Service Bulletin

Product : Dryer
Bulletin # : DFZ202100029-02
Release Date : 21.04.07

[SVC Guide] Service guide according to shape of Cover guide and Filter

1. Repair Instruction (Changes)

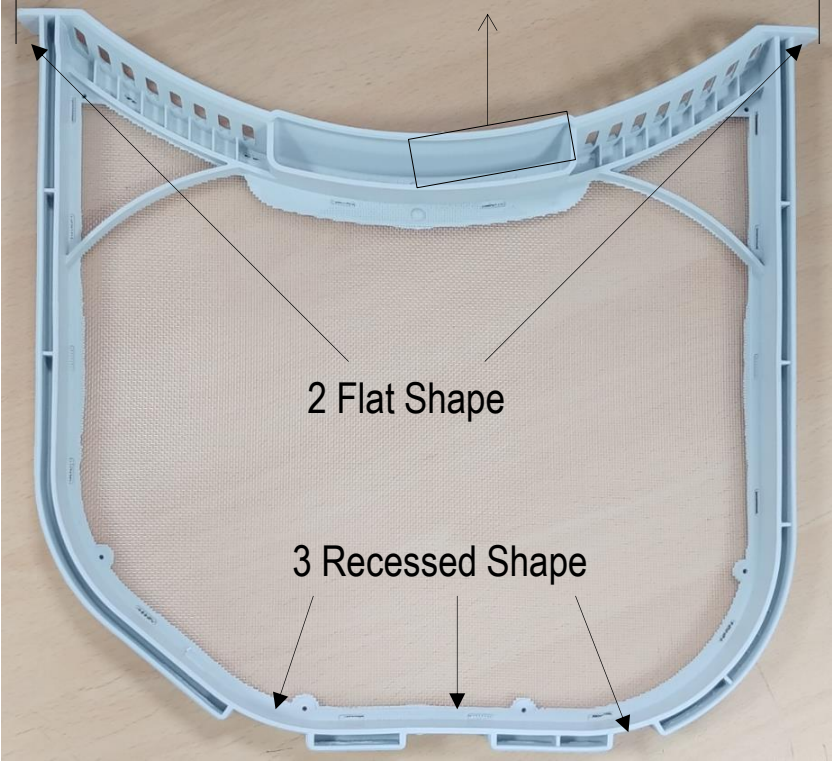
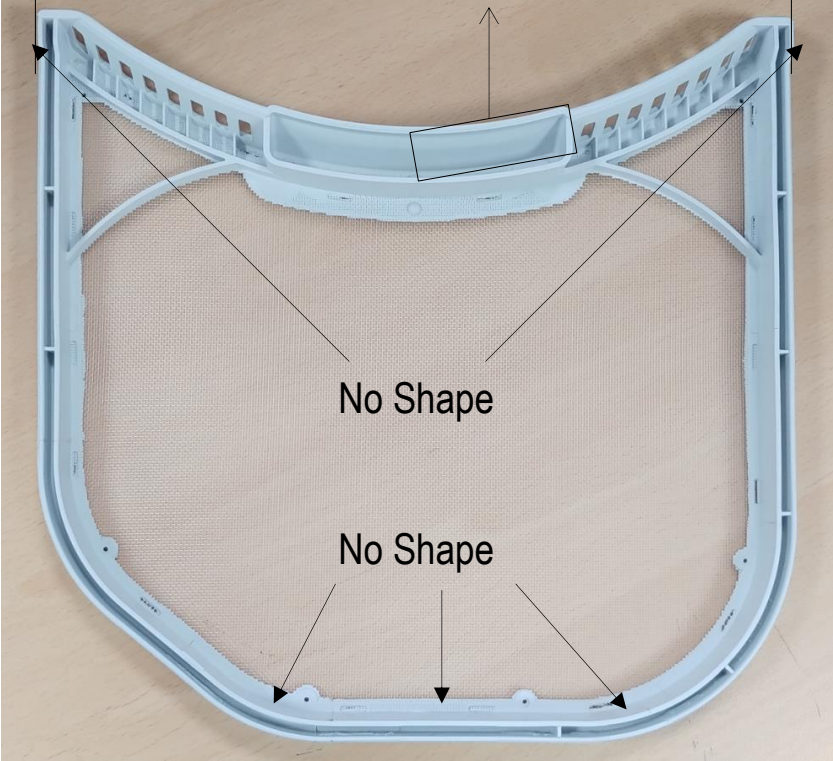
ADQ56656401(Old)

11.88"

ADQ566564 (3 letters, 6 numbers)

ADQ56656403(New)

11.24"

ADQ56656403 (3 letters, 8 numbers)

Serial Number	Classification	Replacement part	SVC Guide
<p style="text-align: center;">~101KW Before Jan. 2021.</p>	<p>Old cover guide and Filter ADQ56656401 applied product</p> 	<p style="text-align: center;">Cover Guide</p>	<p>Change cover guide to New(MCK490491) and filter ADQ56656403 at the same time.</p> <p>When ordering 383EEL3002Q, New cover guide and New filter are provided at the same time..</p>
		<p style="text-align: center;">Filter</p>	<p>Change filter to ADQ56656401</p>
<p style="text-align: center;">102KW~ After Feb. 2021.</p>	<p>New cover guide and Filter ADQ56656403 applied product</p> 	<p style="text-align: center;">Cover Guide</p>	<p>Change cover guide to New(MCK490491)</p>
		<p style="text-align: center;">Filter</p>	<p>Change filter to ADQ56656403</p>
